**Responses to NRC Questions Regarding Salem Bypass Testing During
Teleconference Held on November 28, 2012**

Figure 5-1: Penetration Velocity Distribution

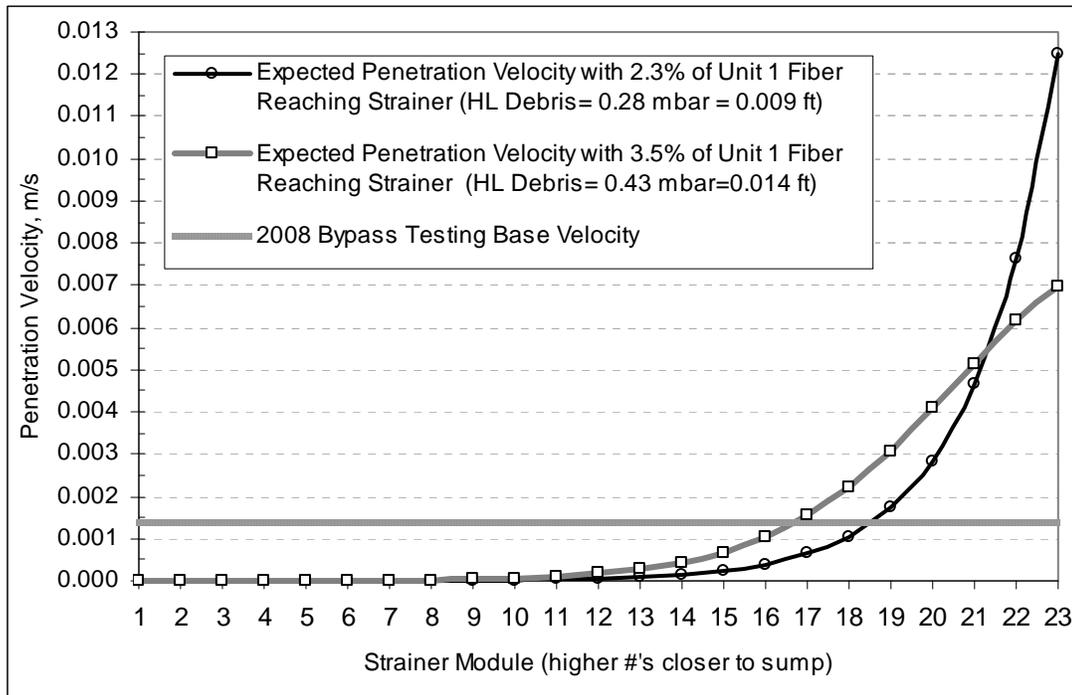
- 5) *The highest reported test velocities were about 80 times lower than the maximum expected velocity for the Salem strainer according to the vortex evaluation. How do velocity gradients of this magnitude affect bypass?*

To illustrate this point, a plot of the expected penetration velocities with approximately 2.3% (1/50" theoretical bed thickness) and 3.5% (1/32" theoretical bed thickness) of the Unit 1 fiber reaching the strainer is shown below (see question 18 for discussion on the ability of thin fiber beds to filter debris). Note, while the strainer and sump pit fill with water before recirculation begins, approximately 2.3% of the fiber will reach the strainer (based on the volume of water in the strainer compared to the volume of water in the sump pool at recirculation initiation assuming uniform debris concentration). The Unit 1 debris load is selected since it has a less uniform penetration velocity distribution due to a lower overall debris head loss than Unit 2 (see Section 3f.10.2 of 2012 Supplemental Response); however, the debris load is conservatively applied to the Unit 2 strainer since it has higher velocities. The plot of expected penetration velocity in each module was generated using the spreadsheets developed as part of the strainer head loss calculation (see Section 3f.9 of 2012

Supplemental Response). Based on a uniform debris concentration in the sump pool, two pump flow, and the strainer head loss being directly proportional to the quantity of debris on the strainer, it is expected that the penetration velocity profiles shown in the figure below would develop quickly after recirculation initiation.

As shown in Figure 5-1, it is expected that at recirculation initiation (when 2.3% of fiber is at strainer) approximately 75% of the strainer modules will experience penetration velocities lower than those tested in the 2008 CCI Bypass Tests. Furthermore, by the time 3.5% of the total Unit 1 fiber debris load has reached the strainer (approximately 25 seconds after recirculation begins), the penetration velocities at the modules nearest the sump are already significantly lower.

Non-uniform velocities could result in modules nearer the sump having a greater quantity of debris than modules farther from the sump due to the higher module approach velocities near the sump. The higher velocities could result in potentially more bypass in the modules near the sump. However, the results of bypass testing which give the mass of bypassed fibers per unit area based on a uniform debris bed/velocity show that additional fiber bypass does not occur beyond a saturation value which was reached during testing (See Question 6). Therefore, application of

For these reasons, the net effect of assuming a uniform velocity gradient when determining the fiber bypass quantity is expected to result in a best-estimate assessment of the total fiber bypass per unit area. Therefore, the velocity gradient across the strainer train will not adversely impact the design basis fiber bypass results.

Photo 10-1

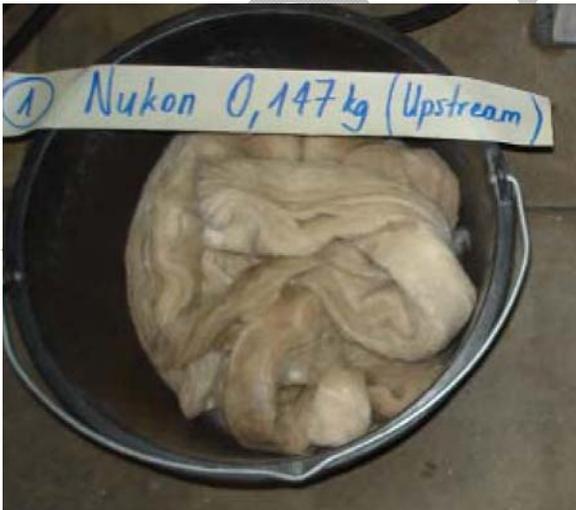
10) Discuss the procedures for debris control during the tests. How were the fibers ensured to all make it into the test tank after weighing and preparation?

The dry fiber material was weighed in separate buckets which were labeled with tape (see Photo 10-1 below). The dry material was then further divided into batches which were soaked with water prior to being blasted with a water jet. The fiber batches were placed in larger bucket(s) in order to accommodate water from the jet blasting. The quantity of debris in these larger buckets was also recorded and placed on a tape label on the bucket (red circle in Photo 10-2). The large buckets were not drained during the water jet blasting to ensure that no fiber fines were lost. The prepared fiber debris bucket was then placed on a scaffold near the MFTL and the fiber slurry was added to the test loop using the dip-bucket method where a pitcher was used to slowly add the debris to the MFTL (green circle in Photo 10-2).

Furthermore, given that the results of the fiber bypass tests indicate that the strainer reaches a fiber saturation value beyond which additional fiber does not result in significant bypass, the loss of a few fibers during preparation and addition would be inconsequential.
